Product Change Notification

Change Notification #: 106061 - 00
Change Title: IXB2800, IXB2800KAS, IXB28004XOC3, IXB28004XOC3FB, PCN 106061-00, Product Design, Design change to prevent resetting of board when switching the redundant power source on and off
Date of Publication: March 18, 2006

Fig.1 Q18 location on C99378-00x baseboard

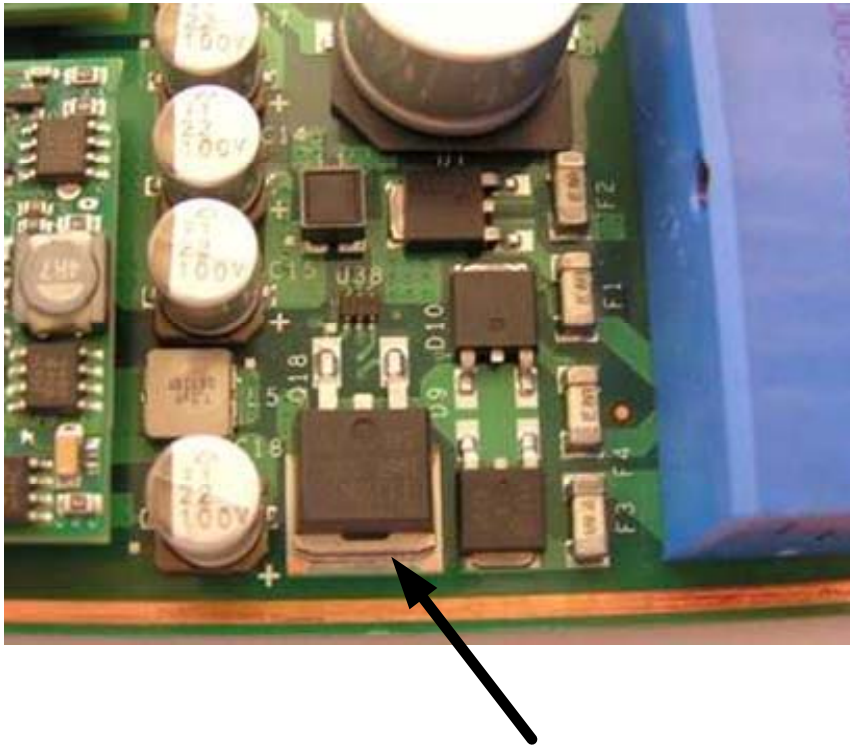
To prevent resetting of the board that is operating when redundant power sources is being switched on and off requires a component change in the input protection circuit. The component to be changed is transistor Q18 located on the baseboard between the blue connector and main DC-DC converters, close to the edge of the board—see Fig.1 below.

Power MOSFET transistor Q18 is replaced with a transistor that has a much lower channel resistance. Since the board reset is initiated by the voltage drop across the channel resistance this change makes the protection circuit less sensitive to transients. This change does not affect ATCA compliance.
